INF GR/DL/5/2

**BMW Presentation, “Proposed Door Test Procedures
Hinged Side Doors”**

Proposed Door Test Procedures

Hinged Side Doors

BMW Side Door (interior view)

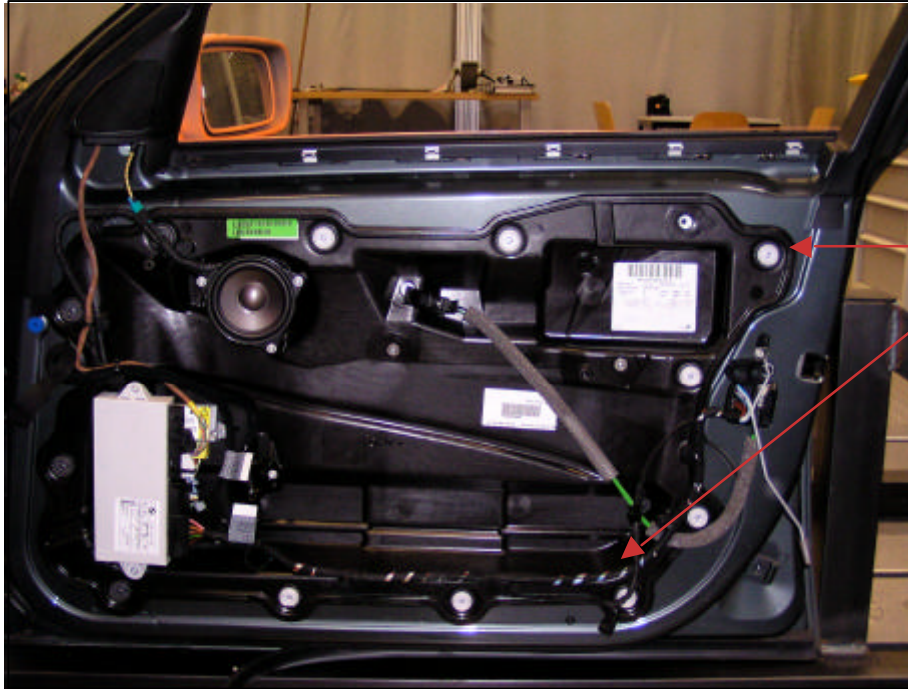
Reinforcement has to remain in place

Reinforcing structure, essential for side door strength located under contoured interior door trim panel.

This part has to remain in place to as not to compromise the strength of the door structure and to ensure correct test results.

However it can become necessary to remove the interior door trim panel to find a supporting structure for force application.

BMW Side Doors (interior view under trim panel) Projections of Parts

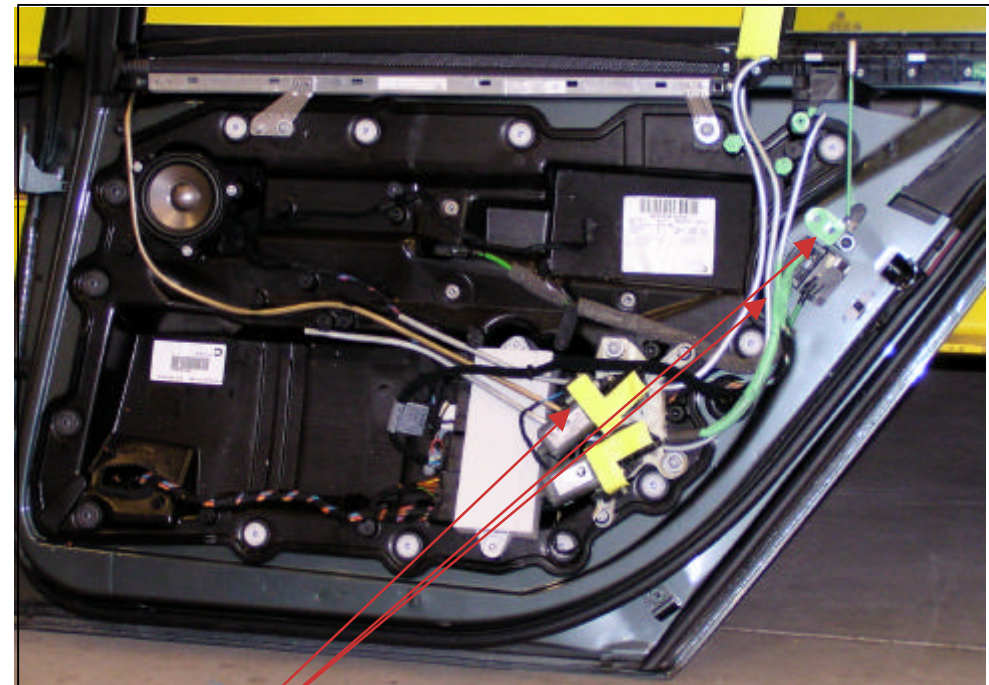
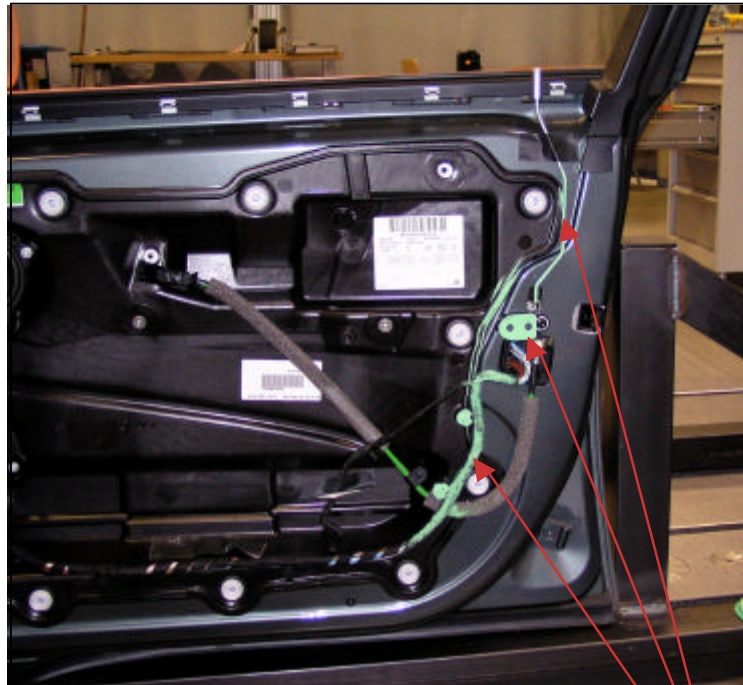
Projections against door structure (highlighted in green and yellow)
Should those parts remain in place or do they need to be removed?

Transversal Force application (Pre-Load)

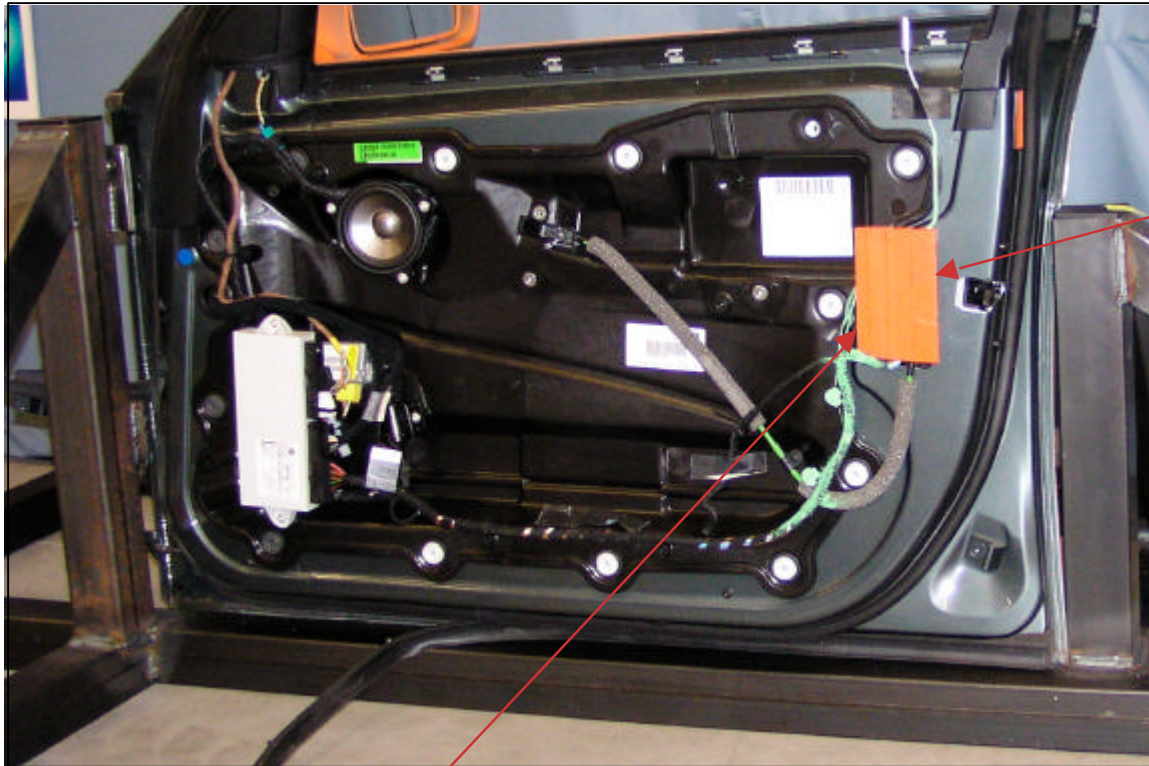
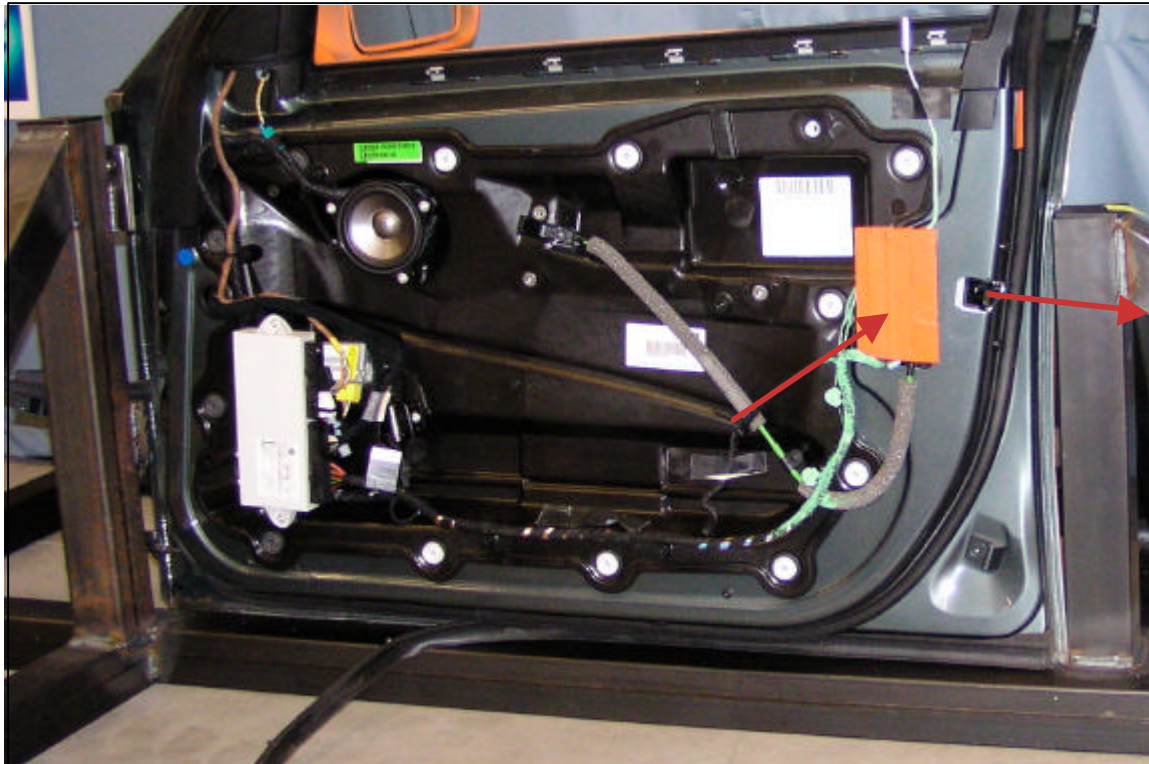
If this Force is
applied before
the longitudinal
Force it will be
increased by the
reaction Forces
of the pulling
cylinders.

Would a static
Force of 1000 N
applied by e.g. a
compressed coil
spring be able to
do the
same/better job?

The requirements of the force application plate need to be defined with regard to radius on outer edges (otherwise it might cut the door)

Suggested sequence of loads:

1. Apply a longitudinal force of 1000 N to get the cylinders under tension.
2. Apply the transversal force of 1000 N
3. Increase the test load of 17000 N until the required time is up.

Direction of Force Application

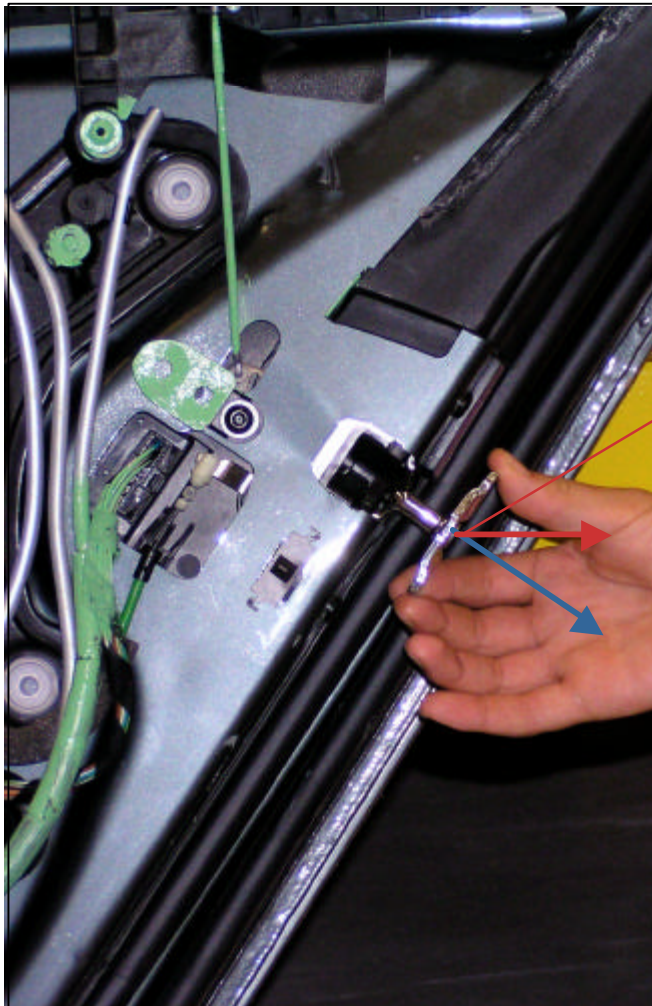
What Force direction is considered longitudinal with regard to door latch/striker assembly?

Longitudinal in vehicle coordinates (red) or longitudinal to latch/striker (blue)?

NHTSA picked the red (x-) direction, that requires a guided hydraulic cylinder.

Direction of Force Application

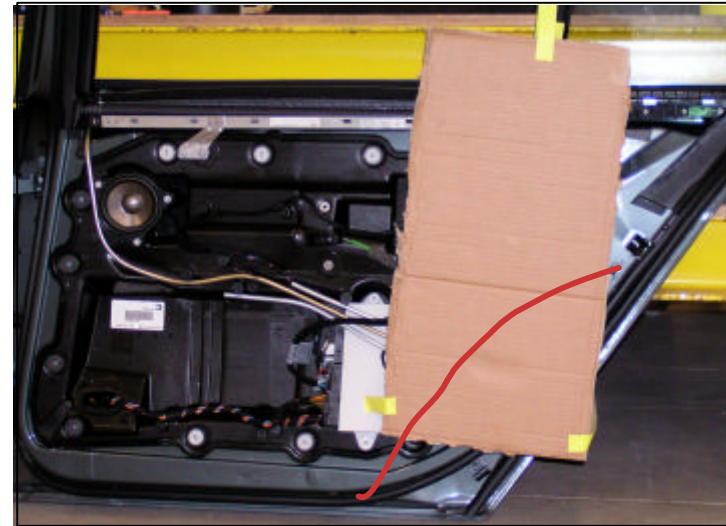
Actual size of rigid plate for lateral testing. For very high side doors (SUVs, special passenger cars, trucks) this size might not be sufficient as it may not be able to engage the structural parts on top and bottom of the door but instead only push against the soft outer door sheetmetal.

On contoured doors (rear doors) there is only a small overlap near the latch, are there any experiences if that is sufficient?

Unrealistic Results/Deformations

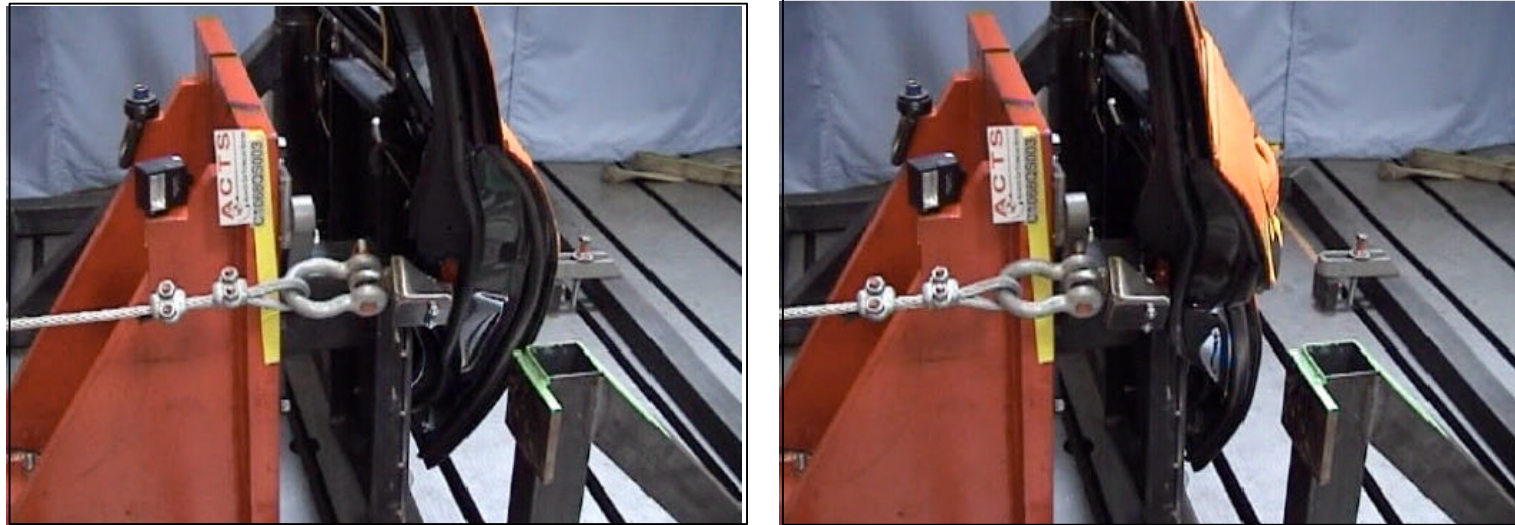
During the lateral testing deformation occurred that does not match the patterns seen in real world accidents. The proposed test setup raises several questions that should be answered :

- Is this test suitable to assess the strength of the latch system or the strength of the door structure (sheetmetal)?
- May the unrealistic deformations cause failure modes that will not occur in real world (due to a better support of complete body)? Might a better support (e.g. by horizontal beams in X-direction) improve this situation?
- What is the effect of the location of the rigid plate relative to the latch?
- What is the effect of the radius of the rigid plate with regard to deformation/Force direction?

(Note: this door passed the test requirements)

Variation of Force Direction

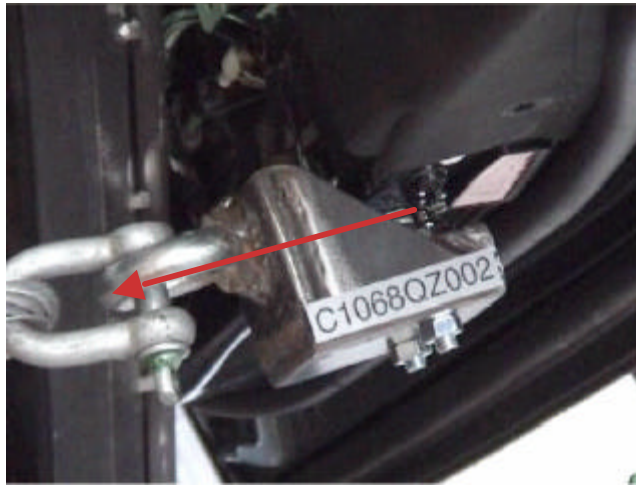
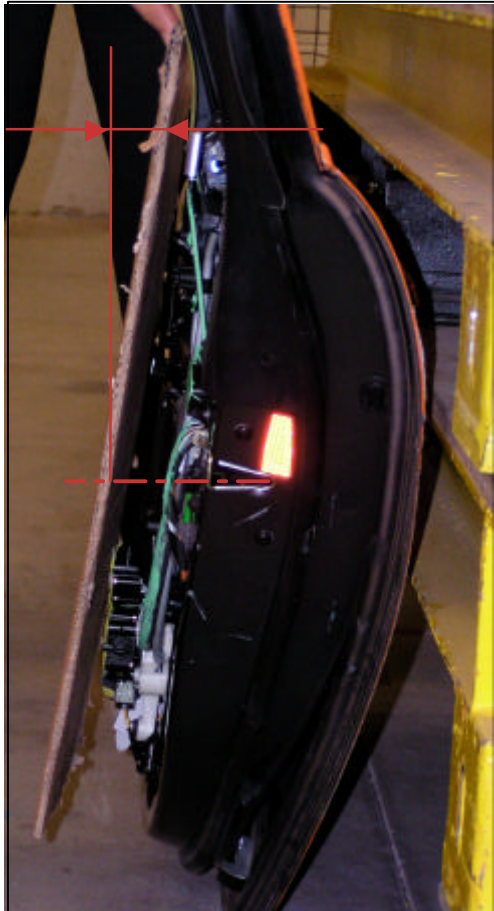
2 Pictures (before and end of test) taken from exactly the same camera position

Due to deformation (bending) of the sheetmetal structure around the edge of the rigid plate the effective force direction varies during the test and/or moments are applied to the latch/striker/door structure assembly that do not occur in real world crashes.

-The moments created during the test will vary with the distance between the latch and the rigid plate. Was that intended? Won't that cause differences between test labs using different equipment and therefore varying the distance between latch and rigid support plate?

-The deformation and thereby the variance of the forces/moments during the test will vary over the shape/contour of the door due to resistance against bending (contoured design of rear doors, projections).

-The edge of the rigid plate needs a well defined large radius to avoid damages of the door structure

-We are still afraid that the proposed test setups will be design restrictive

Direction of Force Application

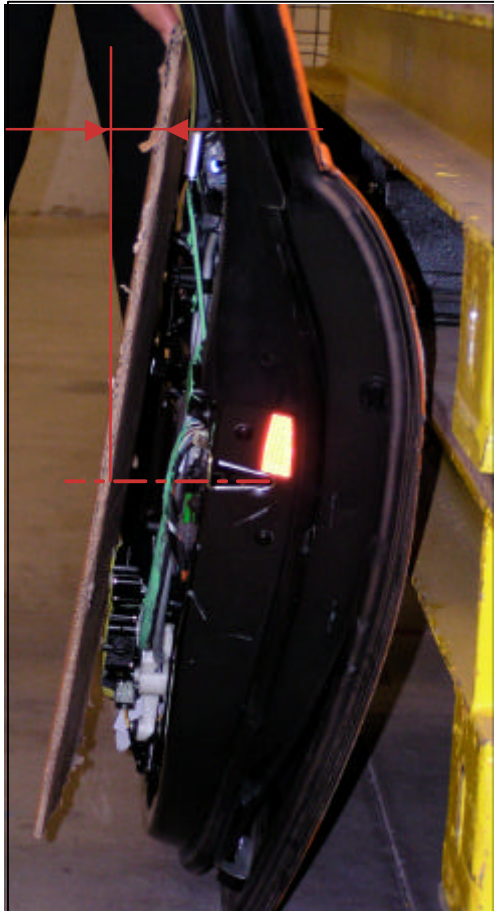
Due to projecting parts and contour of the door firstly only two small areas of the door will get in contact with the rigid plate, one consisting of the window frame and the other of the projecting parts.

Was that intended?
Should the projecting parts be removed for testing?
